UNITED STATES PATENT AND TRADEMARK OFFICE

APPLICATION NO.	FILING DATE	FIRST NAMED INVENTOR	ATTORNEY DOCKET NO.	CONFIRMATION NO.
10/737,330	12/17/2003	Michael Anthony Zerillo		7560
7590 10/18/2005				
MICHAEL A. ZERILLO 15821 E. JERICHO DR. FOUNTAIN HILLS, AZ 85268				
		EXAMINER HAWK, NOAH CHANDLER		
		ART UNIT 3637 PAPER NUMBER		
DATE MAILED: 10/18/2005

Office Action Summary

DETAILED ACTION

Small, Figure 2

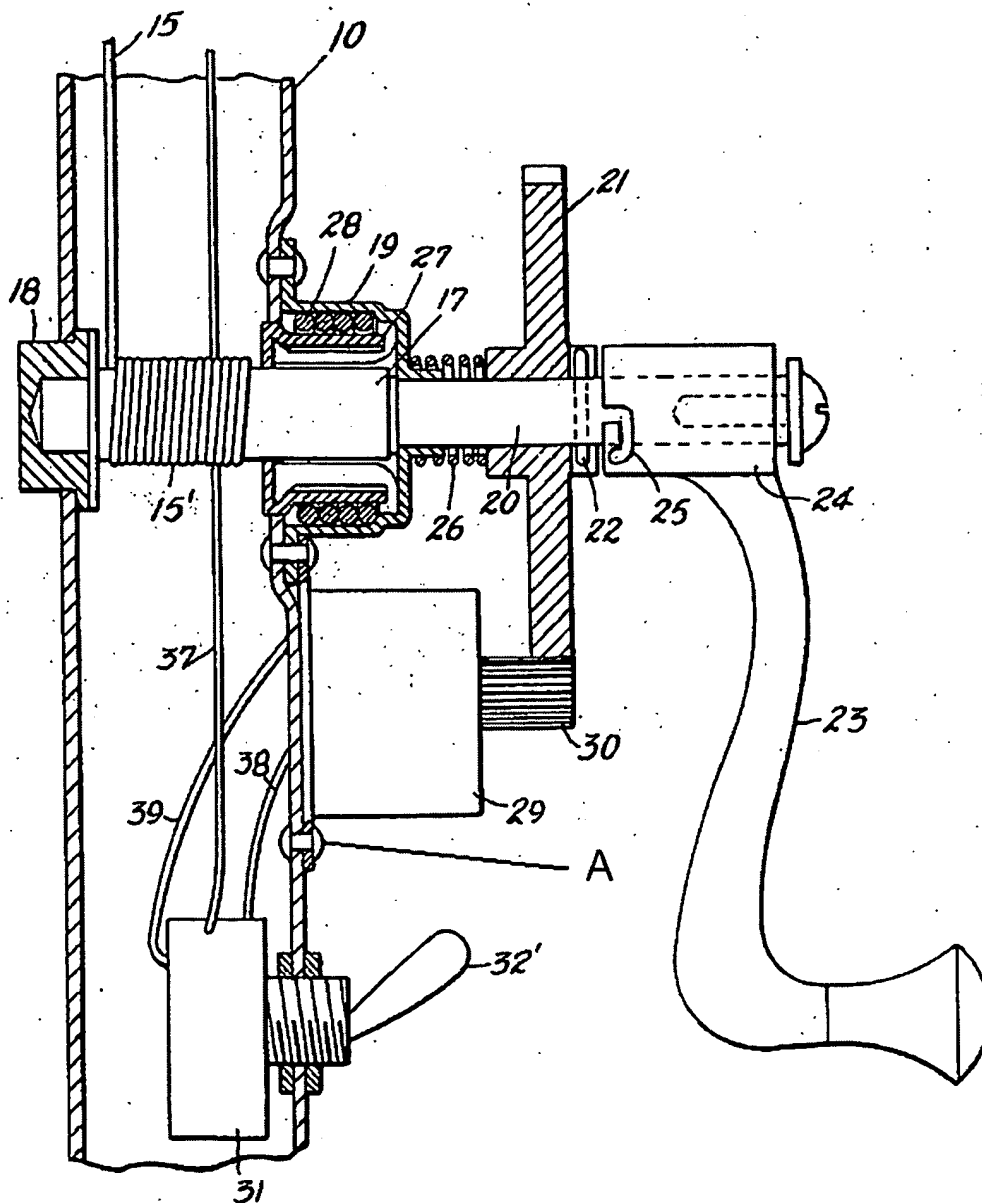
2. Claim 1 is rejected under 35 U.S.C. 103(a) as being unpatentable over Lai in US Patent 6182917 in view of Small in US Patent 2960094. Lai discloses a "retrofit" electric opening and closing device for new and existing umbrellas, the device comprising a reversible electric motor (21), a reel drivingly engaged with the motor (24) a housing means for the motor and the reel (12), a length of cable (33) affixable at one end to the reel, a means to provide electricity (See Lai, Column 2, lines 14-15), a switch (10) having two means (See Lai, Column 4, lines 12-15) to connect or disconnect the electricity to the motor, a remote control receiver (11) having two means (See Lai, Column 4, lines 12-15) to connect or disconnect the electricity to the motor, and a remote control transmitter (See Lai, Column 1, lines 26-28) having means to control the remote control receiver. Lai is silent on which direction the motor turns it relates to the controlling element of the switch or remote receiver. However, it would be obvious for the engagement of a first means in a controlling element such as a switch or a remote receiver to connect electricity to the motor and cause the motor to turn in a first direction of rotation thereby causing the umbrella to open, and for disengagement of the first

means of a switch or remote control receiver to disconnect electricity from the motor and cause it to stop rotating in a first direction thereby causing the umbrella to stop opening. Further, it would be obvious for the engagement of a second means in a controlling element such as a switch or a remote receiver to connect electricity to the motor and cause the motor to turn in a second direction of rotation thereby causing the umbrella to close, and for disengagement of the second means of a switch or remote control receiver to disconnect electricity from the motor and cause it to stop rotating in a second direction thereby causing the umbrella to stop closing. Lai does not disclose that the opposite end of the cable is affixable to the patio umbrella opening and closing means, nor does he disclose a means to affix the housing to the patio umbrella at a location to thereby establish control of the patio umbrella opening and closing means. Small discloses a motor device for an umbrella, the device having a cable (15) affixed at one end to a reel (17), the opposite end of the cable being affixable (See Small, Column 1, lines 50-54) to the patio umbrella opening and closing means (13). Small also discloses a means (A) to affix the housing to the patio umbrella at a location to thereby establish control of the patio umbrella opening and closing means. It would have been obvious to one of ordinary skill in the art at the time of invention to modify the device of Lai by using a cable attached at an opposite end to the patio umbrella opening and closing means and to use a means to attach the housing a location to thereby establish control of the patio umbrella opening and closing means as taught by Small in order to ensure that the motor is in control of the operation of the umbrella and that it is firmly attached at a convenient position to the umbrella. Please note that it has been held that

the functional "whereby" statement does not define any structure and accordingly can not serve to distinguish. Therefore, the limitation "whereby a person with ordinary skill can attach the device to the opening and closing means of the patio umbrellas with little or no modification" has been given no patentable weight. *In re Mason*, 114 USPQ 127, 44 CCPA 937 (1957).
